Project BLACKTOWN WORKERS SENIORS LIVING - INDUSTRIAL PARK ROAD ANDRELL PARK NSW	Scale As indicated @A1	Drawing Title MASTERPLAN - SECTIONS - SHEET 1	Issue B
Client Paynter Dixon www.paynter-dixon.com.au	Author AJ+C ALVIN JENNY COTTELL 79 Maple Street, Chippendale NSW 2008 AUSTRALIA ph +61 2 8511 8222 fax +61 2 8511 8200 ABN 53 003 762 250	Sheet Status NOT FOR CONSTRUCTION	Project No. 17002

Project	BLACKTOWN WORKERS SENIORS 170 RESERVOIR ROAD ANNIELL PARK, NSW	Scale	1:200 @A1	Drawing No.	DA2100 D																									
Architect	AJ+C 78 Maple Street, Chesham NSW 2869 AUSTRALIA PH +61 2 8311 8221 x +61 2 8311 5200 ABN 53 003 762 250	Drawing Title	STAGE 1 - LEVEL 1 (GROUND) PLAN																											
Client	PAYNTER DIXON CREATING SINCE 1914 www.paynterdixon.com.au	Drawing Scale	NOT FOR CONSTRUCTION																											
Key																														
Revisions

BLACKTOWN WORKERS CLUB SENIORS LIVING

MASTERPLAN REPORT - LANDSCAPE

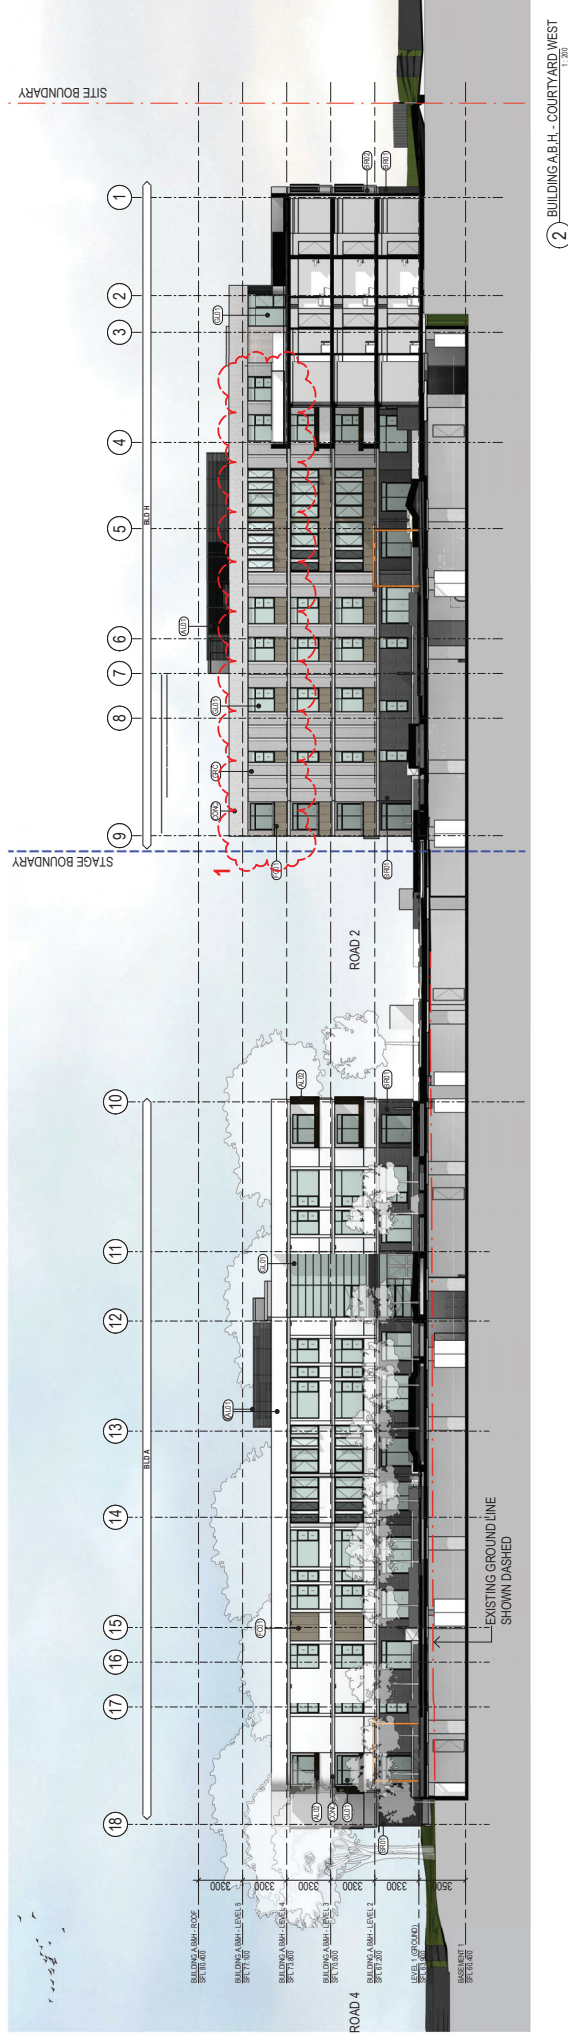
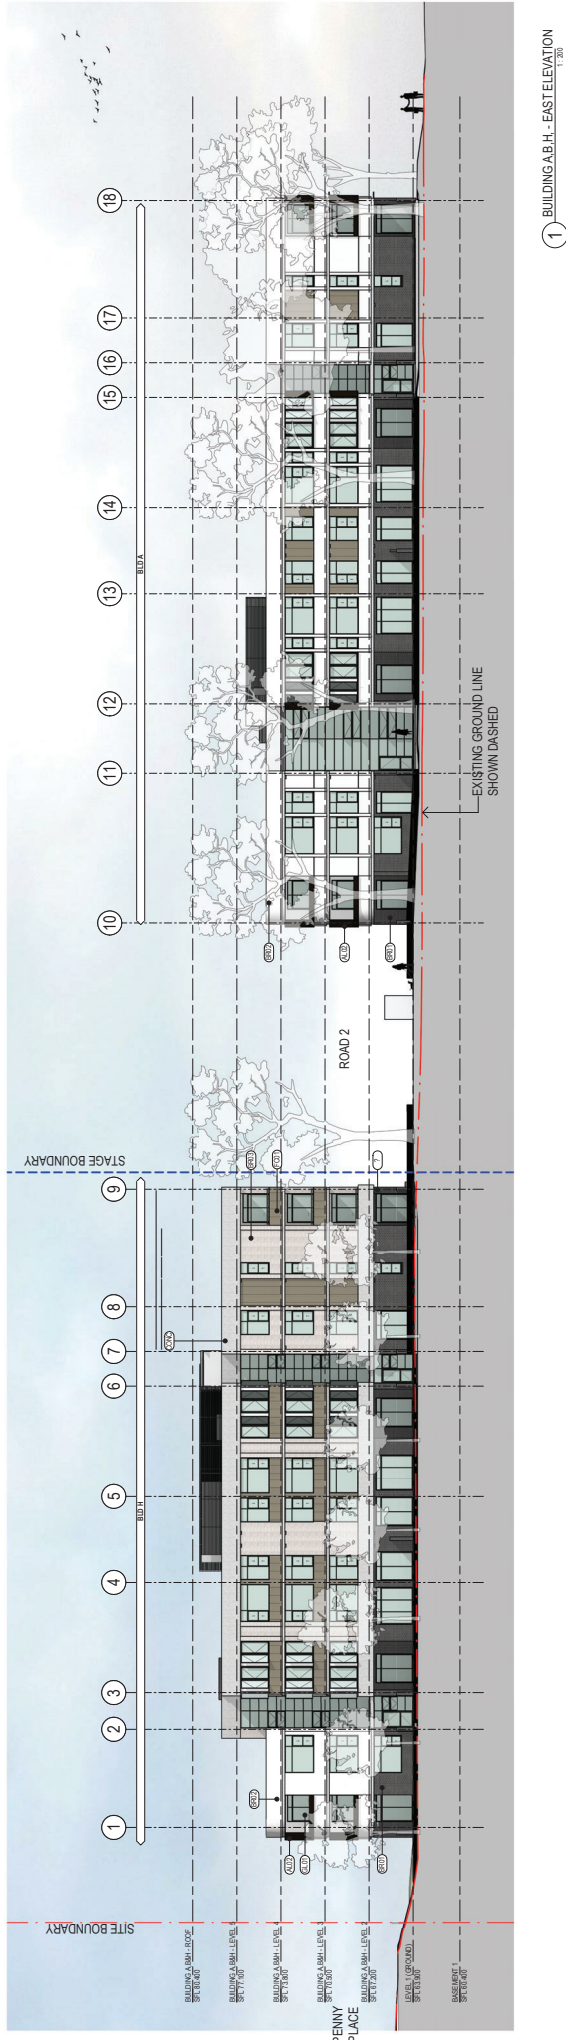
DA MODIFICATIONS: STAGE 2 LEVEL 4
1. WINDOWS AMENDED AS A RESULT OF APARTMENT'S BEING RELOCATED - NO CHANGE TO APARTMENT MIX OR FLOOR AREA

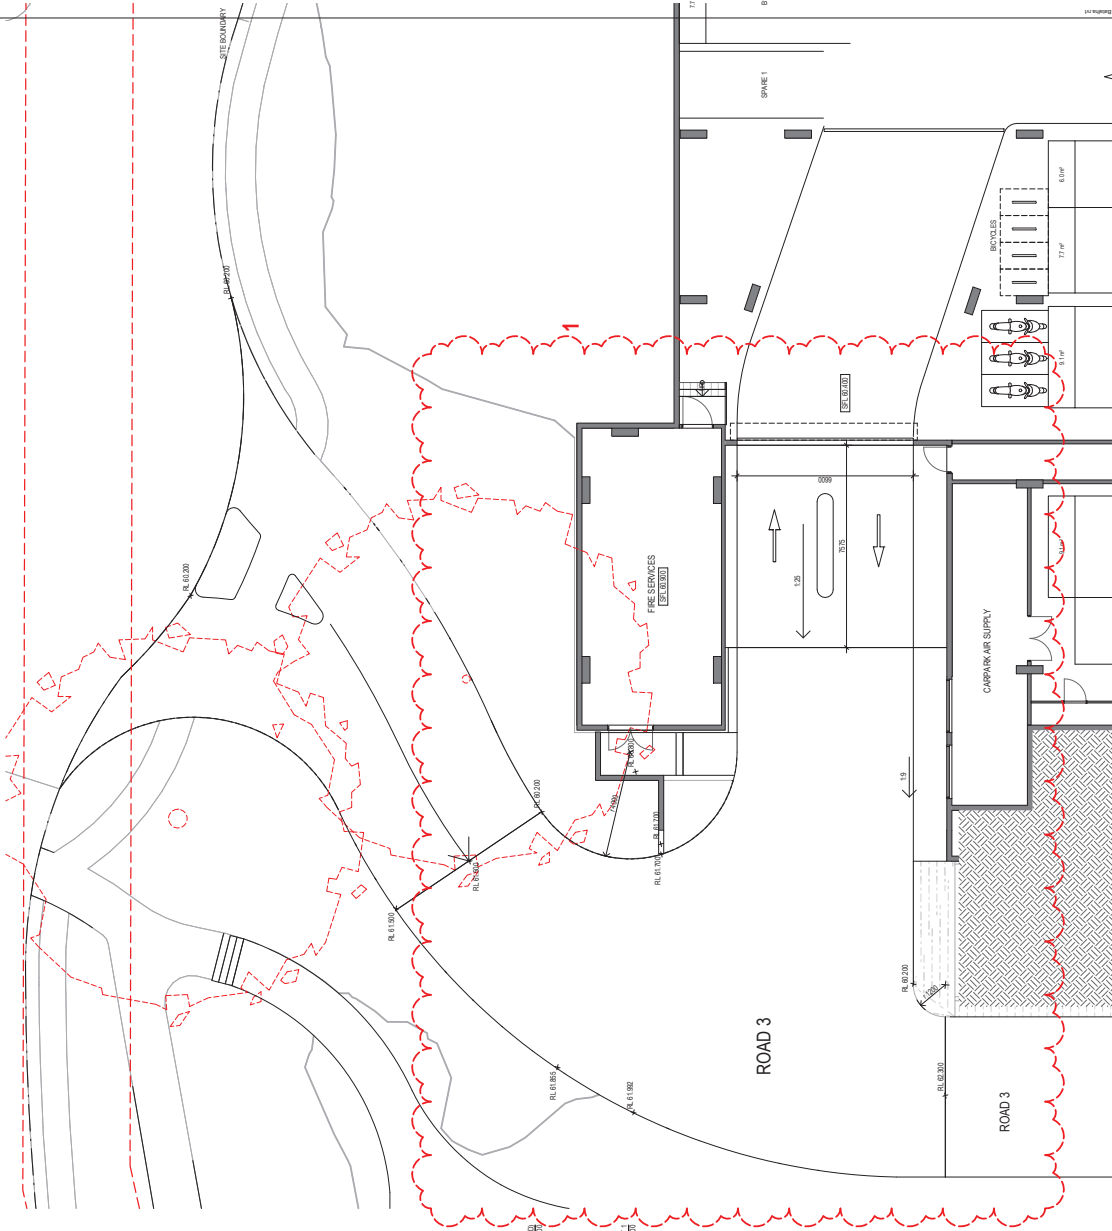
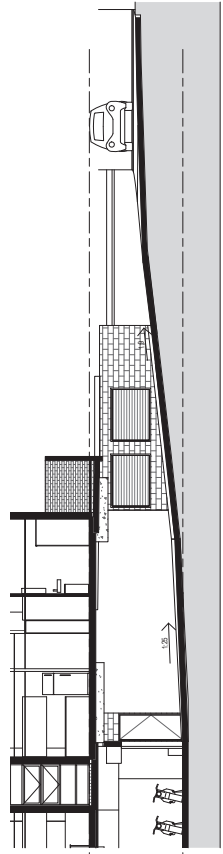
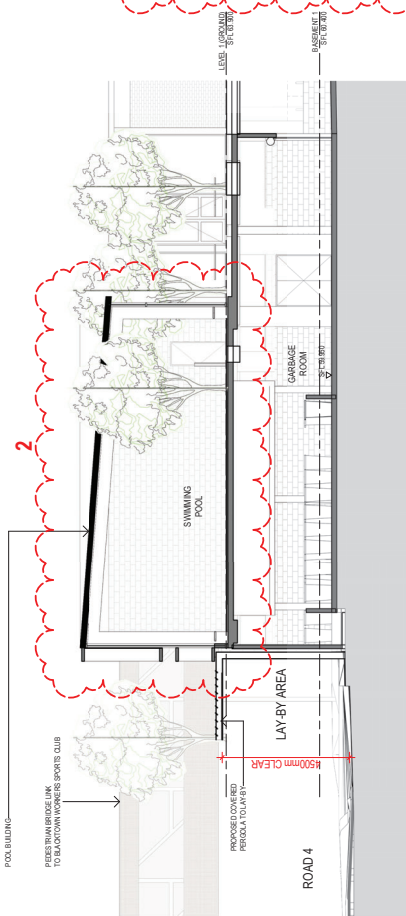
DA MODIFICATIONS: DRIVEWAY
1. DRIVEWAY TURNING CIRCLES INCREASED FOR MANOEUVRABILITY AND CARPARK AIR SUPPLY ROOM
RELOCATED TO ACCOMMODATE LARGER FIRE SERVICES ROOM
2. SWIMMING POOL BUILDING INCREASED TO COMPLY WITH REGULATIONS
